City of Huron Agenda for the Planning Commission/DRB Wednesday, August 16, 2023 5:00pm.

RE: Sawmill Creek Re-Zoning Public Hearing & Recommendation

FROM: Erik Engle, Planning Director **RE:** Seven Lakeway Refractories

CONTRACTORS DESIGN ENGINEERING, LTD.
1623 OLD STATE ROAD
NORWALK, OHIO 44857
PHONE (419) 663-0885
FAX (419) 663-2805
E-MAIL - ADAM@CONTRACTORSDESIGNENG.COM

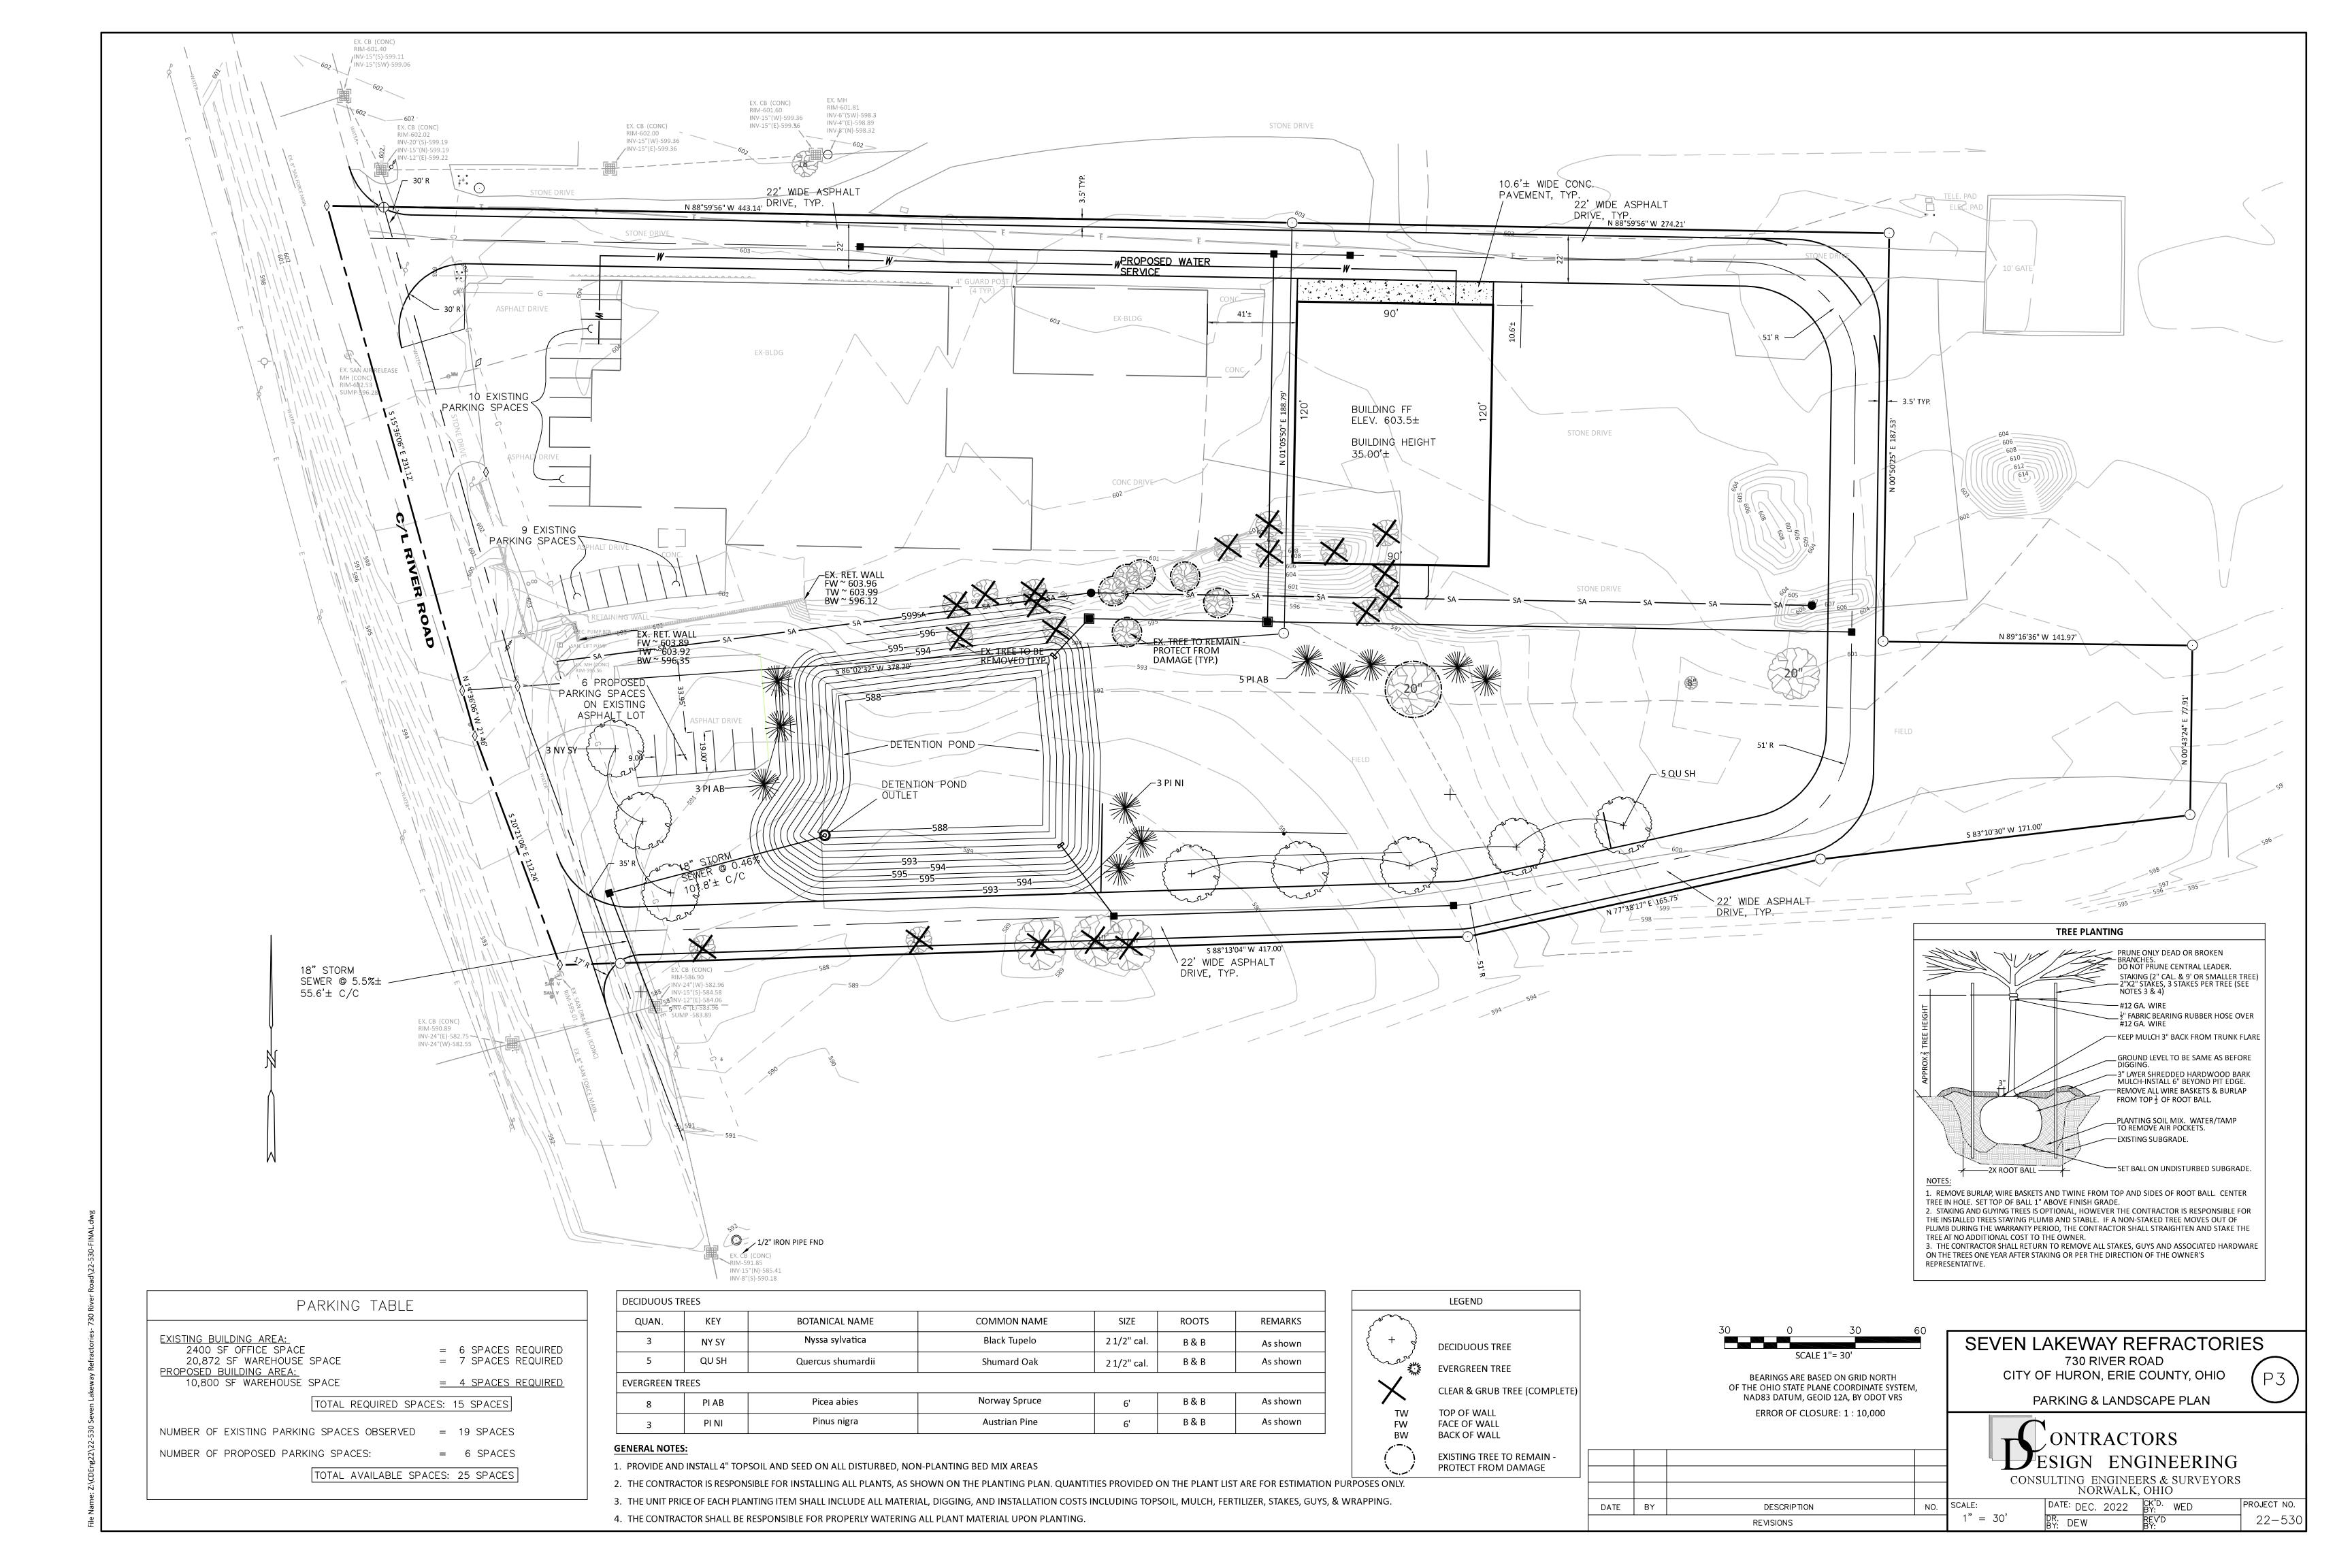
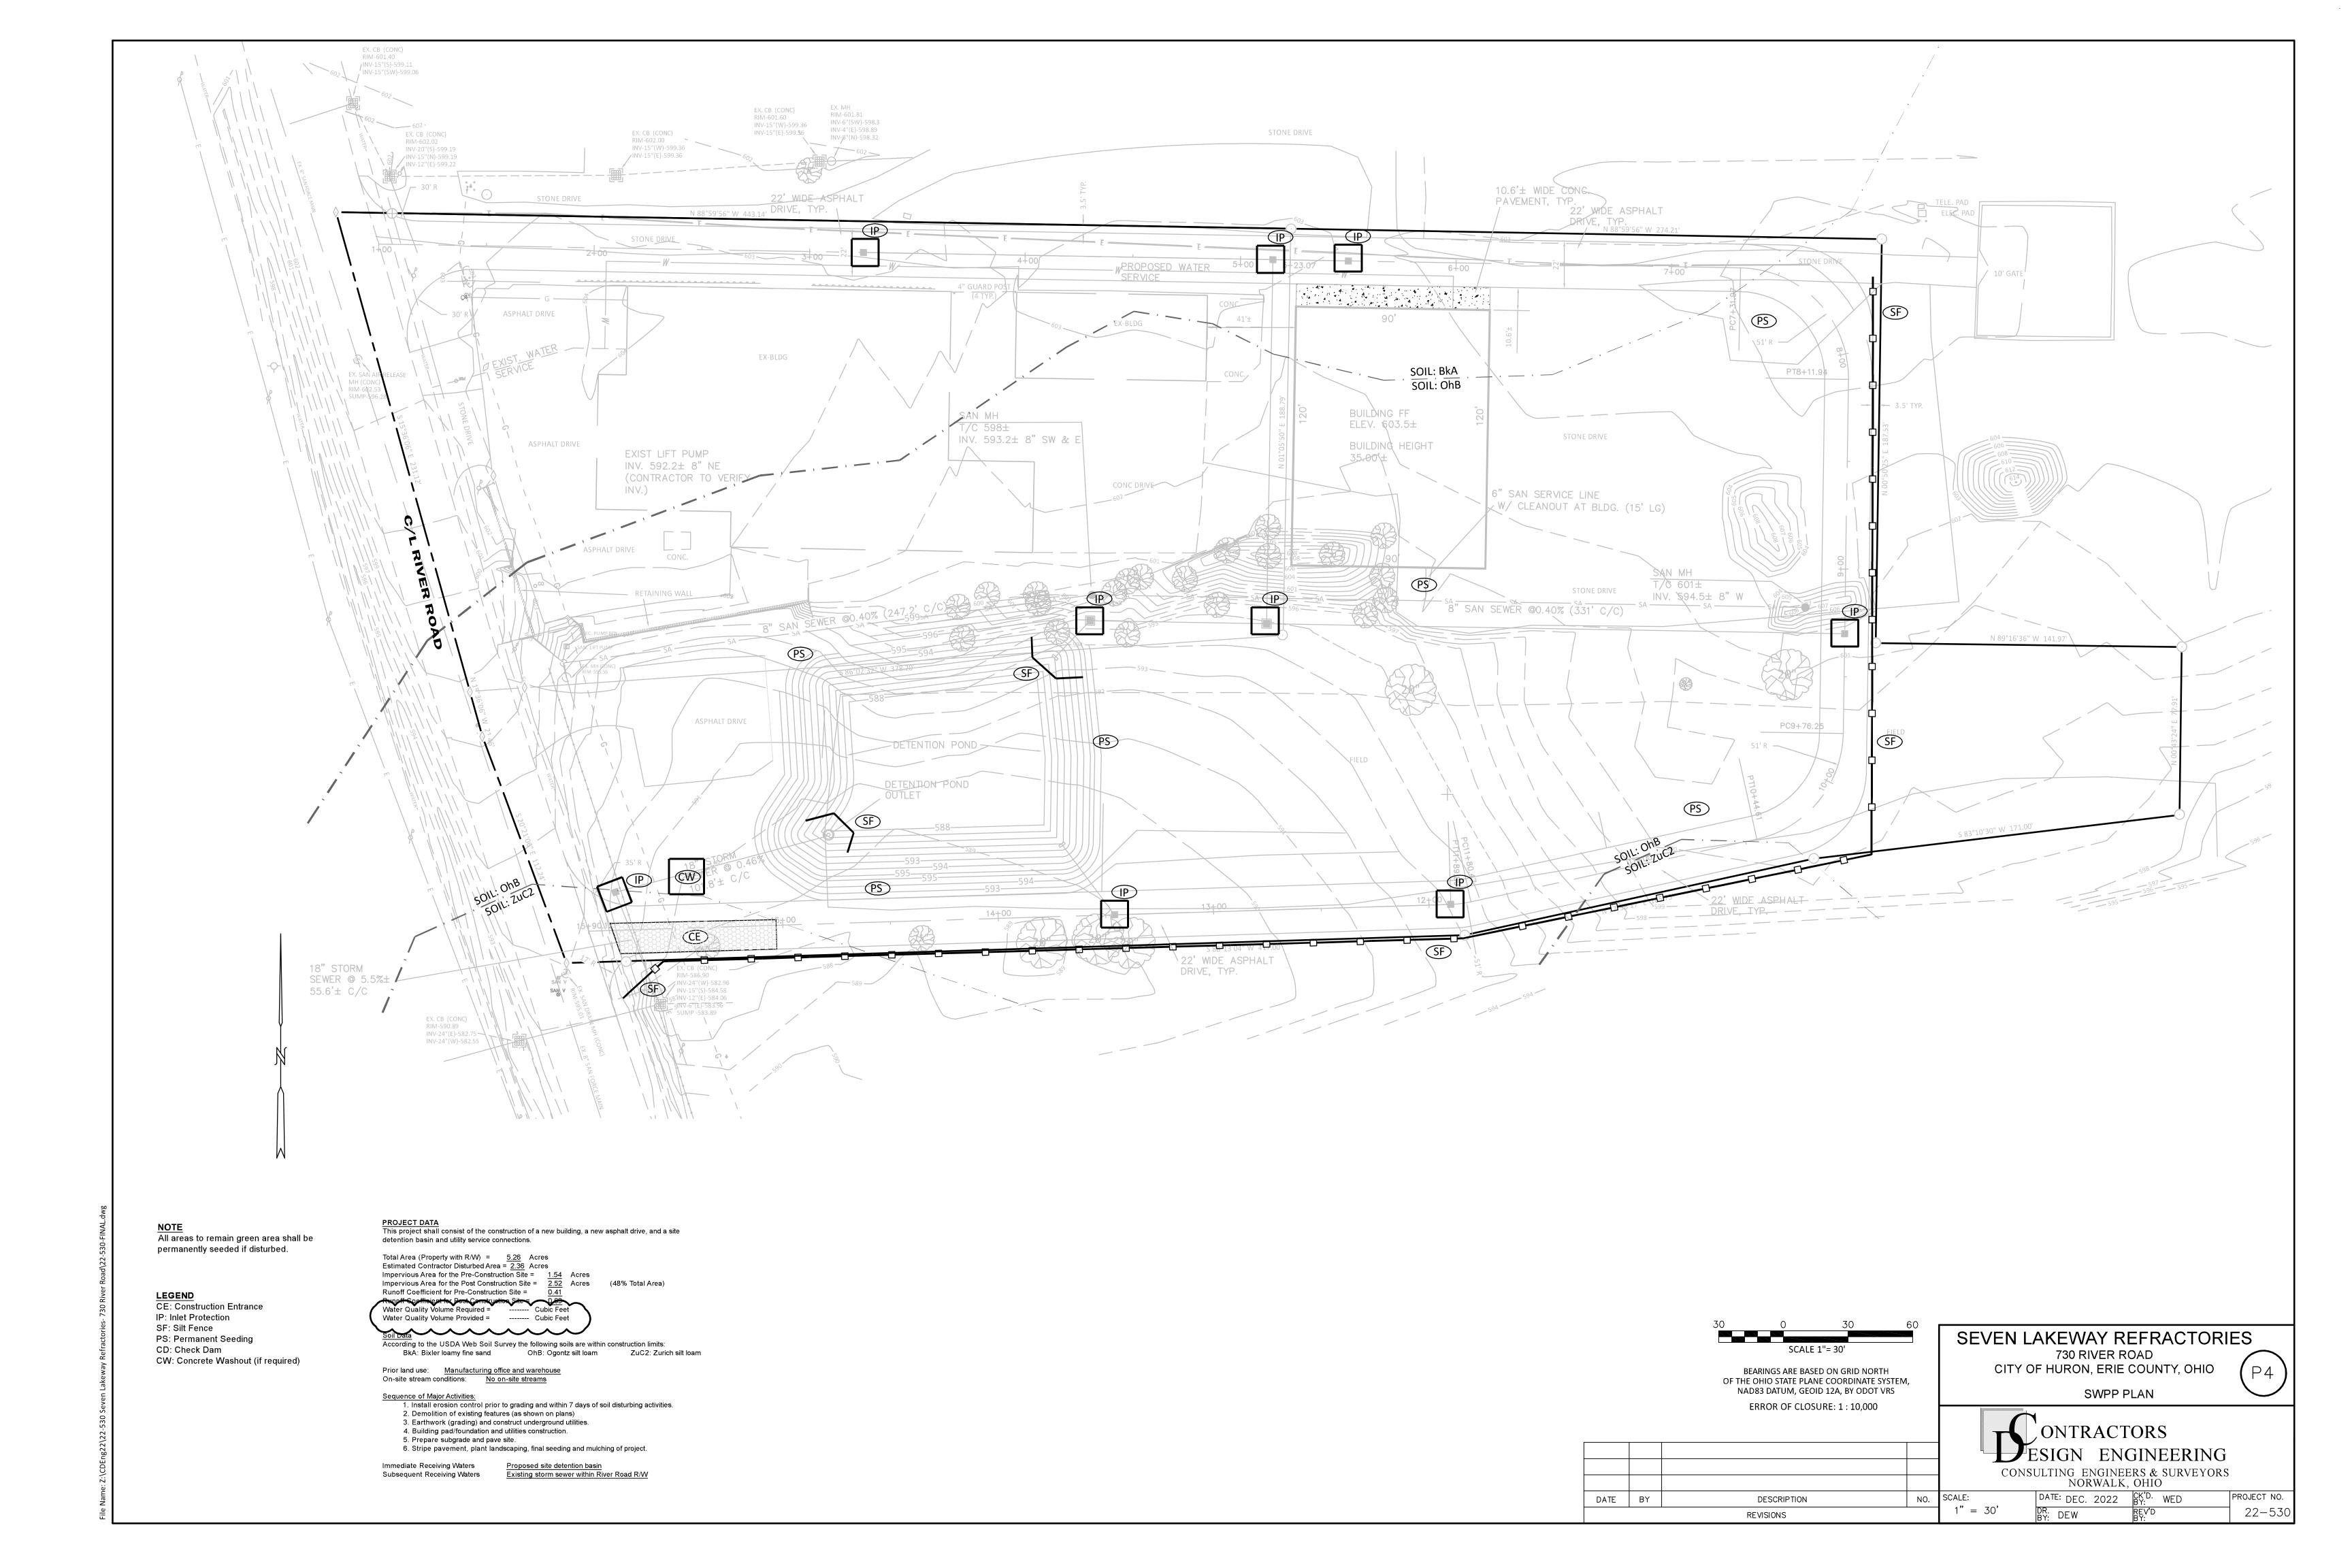
As proposed, the plans include a new 10,800sf warehouse building which meets all site plan regulations for an I-2 Zoning District. The building will be constructed of steel roof and wall panel; proposed wall panel color will be Ash Gray. Exterior lighting includes two wall mounted, shielded, LED fixtures on each side of the building. A landscaping plan has been included.

The landscape plan meets all required standards related to plantings and islands. Perimeter parking lot landscaping shall be incorporated pursuant to 1131.05 along the northwest corner of the front parking lot along River Road.

Stormwater mitigation has been addressed and incorporated into the site plan/design proposal in the form of a detention pond.

The proposed site plan will utilize existing lots with the spaces clearly demarcated. The total number of spaces proposed is 25 parking spaces meeting the 12 required by code. The proposed

site plan will improve ingress/egress of truck trailers by incorporating a paved loop road for deliveries and shipments.

Staff recommends approval of the site plan and design with the following conditions:
